### VARIANCE APPLICATION

HARPSTER RESIDENCE

RE: Project 239 Crossing Crk N Variance Comment Letter

## STAFF REPORT

Enlarged Site Plan

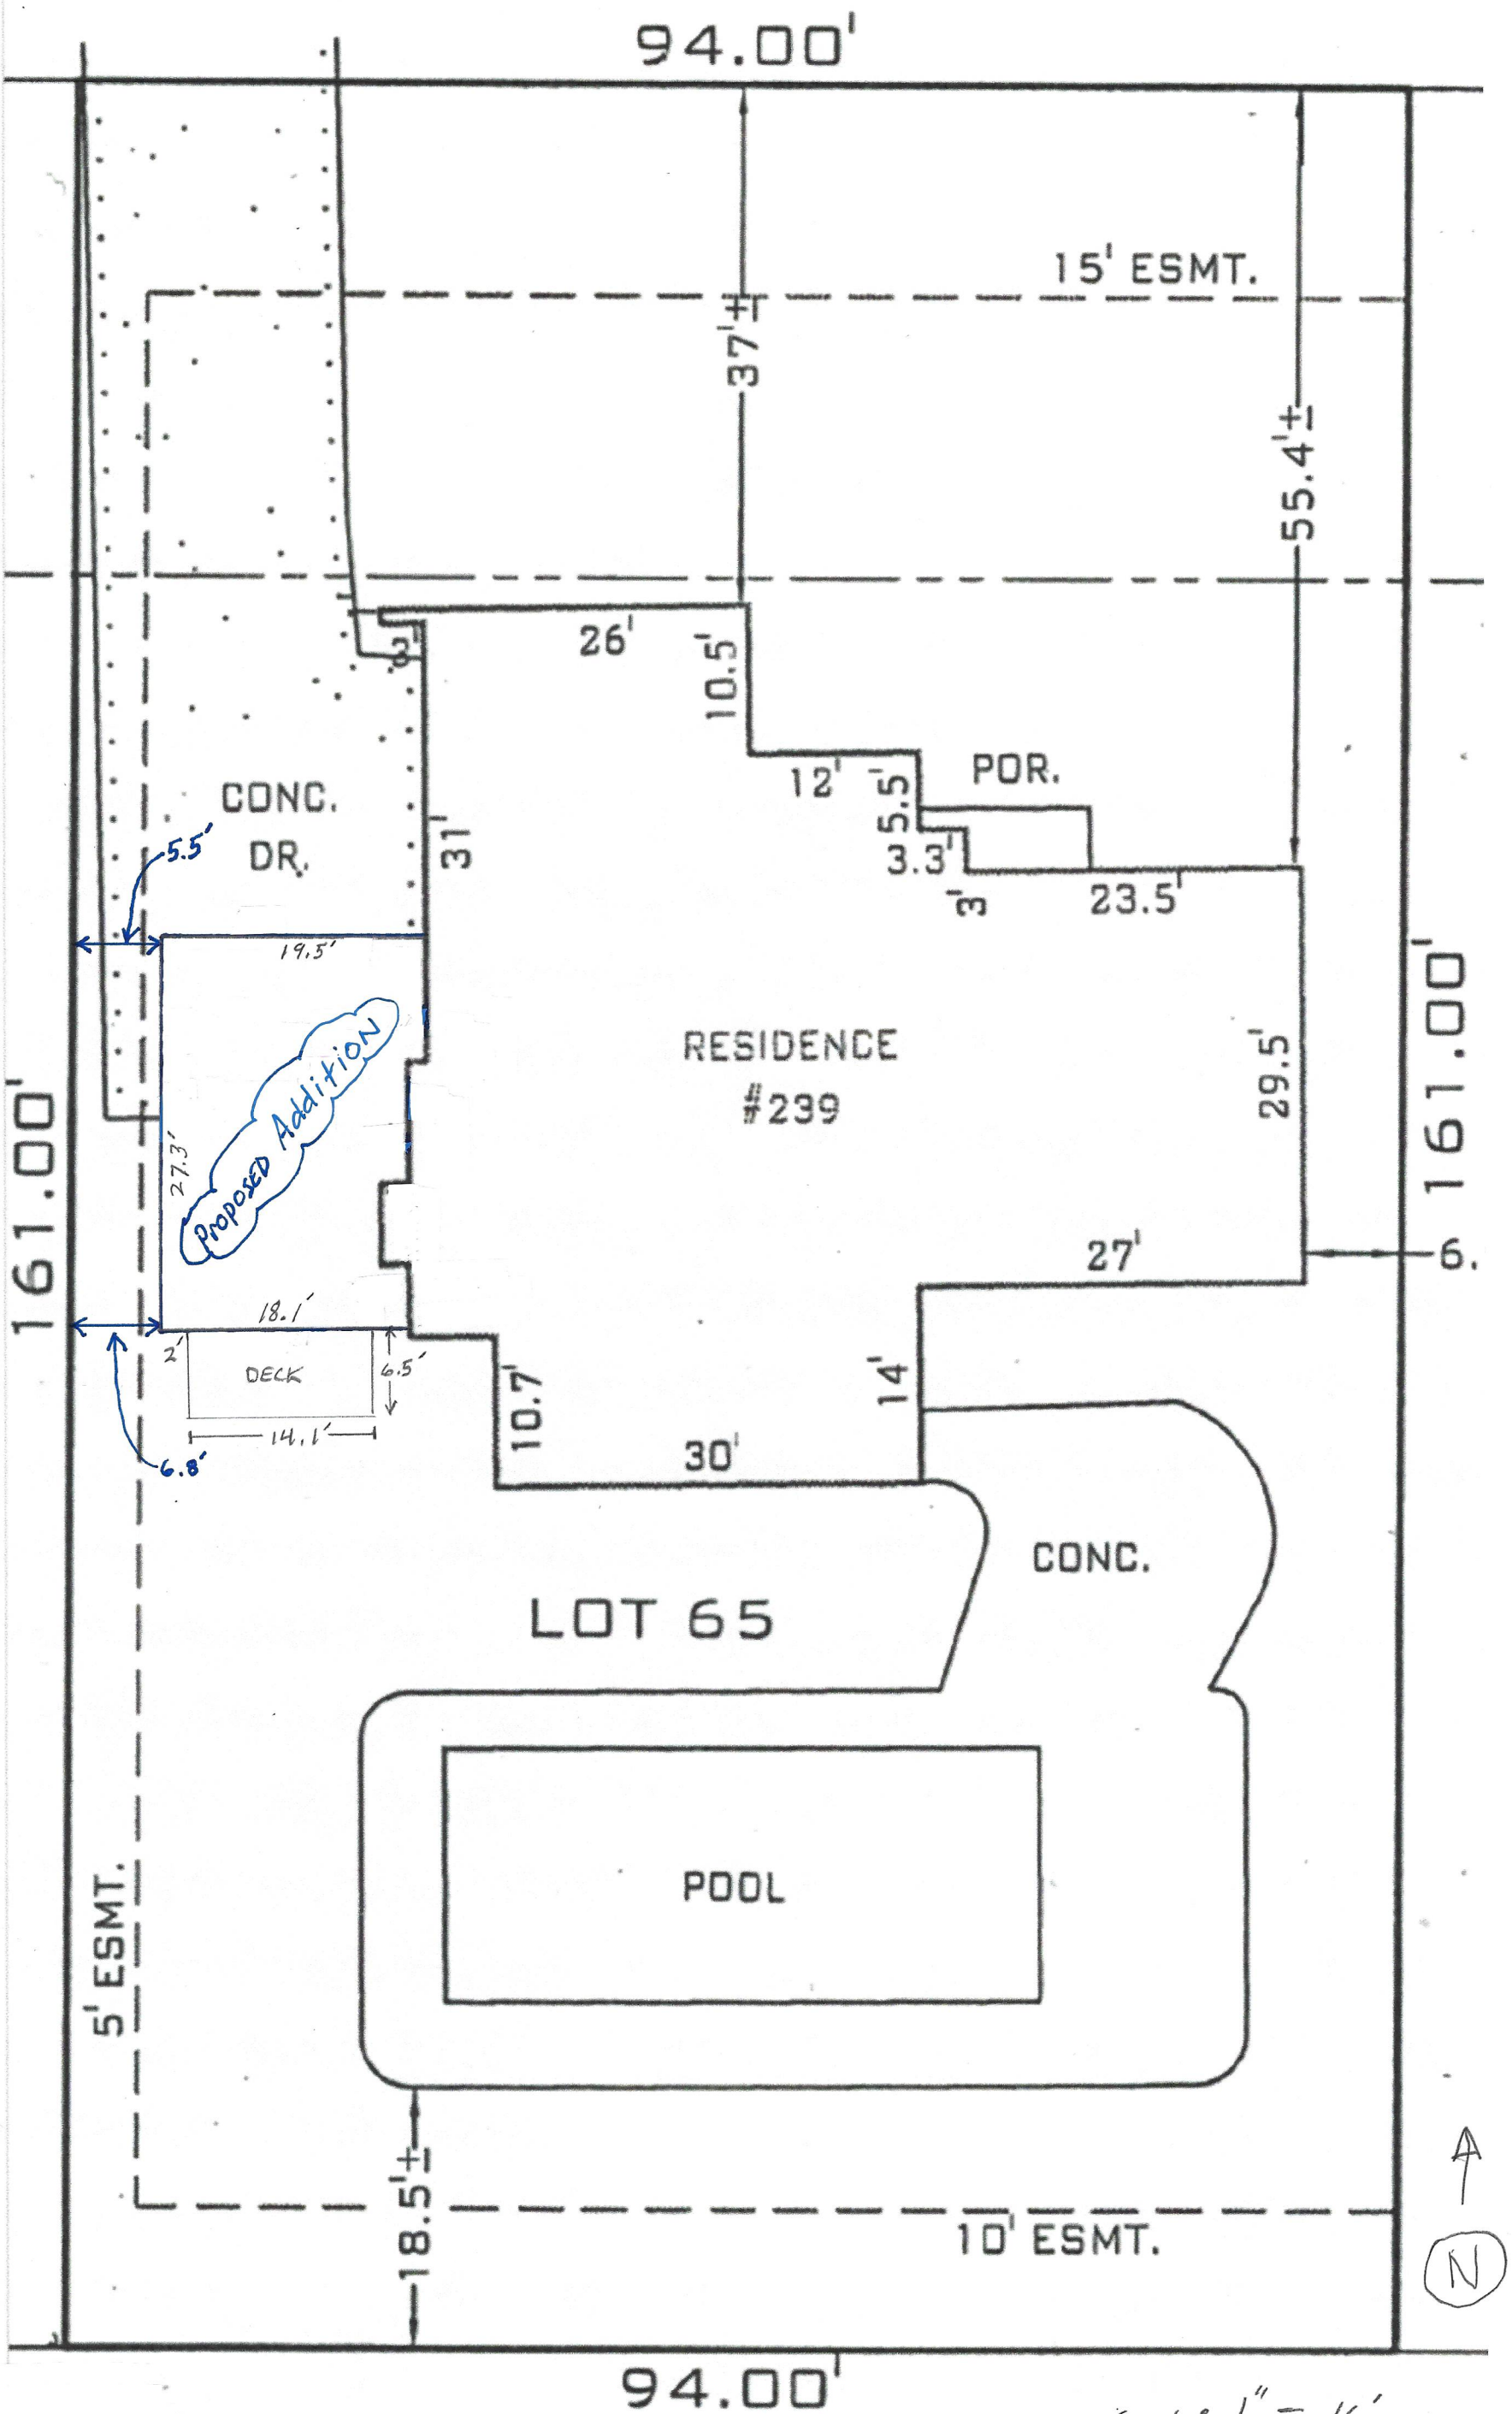
- 3.
- 4.
5. The size of the site plan is difficult to read (approximately 75% of the page are notes that aren't relevant
6. to the variance). Please enlarge the site plan or modify the original survey to show the requested improvements. This will be beneficial to discussions at the public hearing.
- 7.
- 8.
- 9.

Refer to attached drawing.

## Site Plan

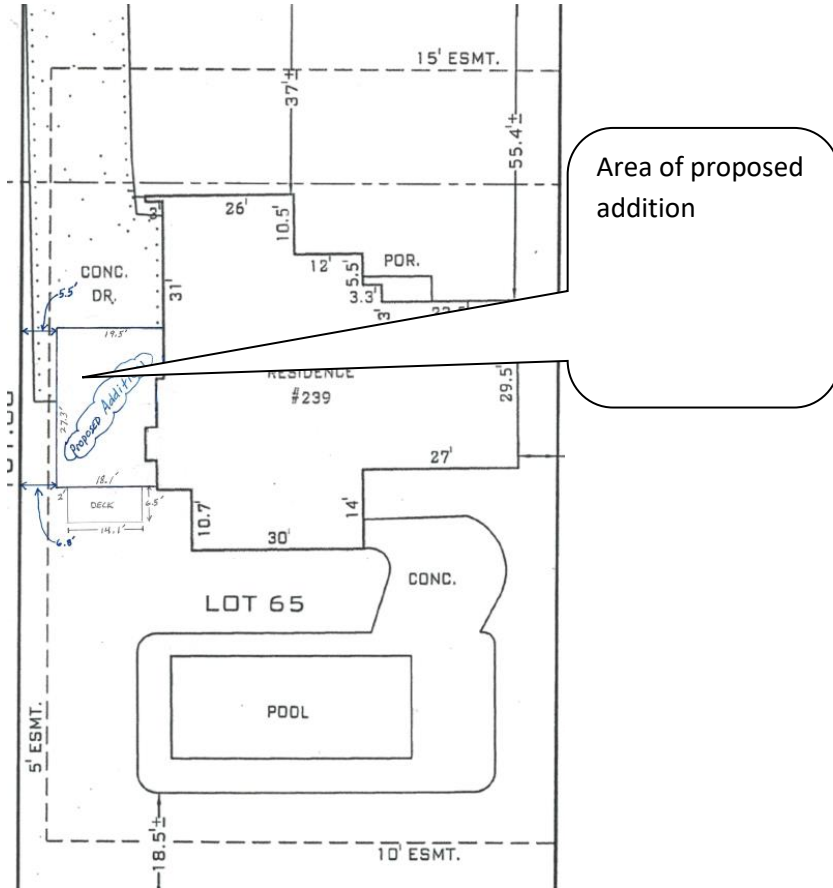
There appears to be limited space for the addition as the survey indicates much of the rear yard is occupied by a pool. Staff does have concerns with side yard setbacks well below code requirements on both side yards. Doing such can give the appearance of the lot being overbuilt. However, the neighboring home to the west, the area of the variance, does not have any windows on this elevation. This should help minimize any negative impacts of the variance on the neighboring property but does not mitigate impacts from the street.
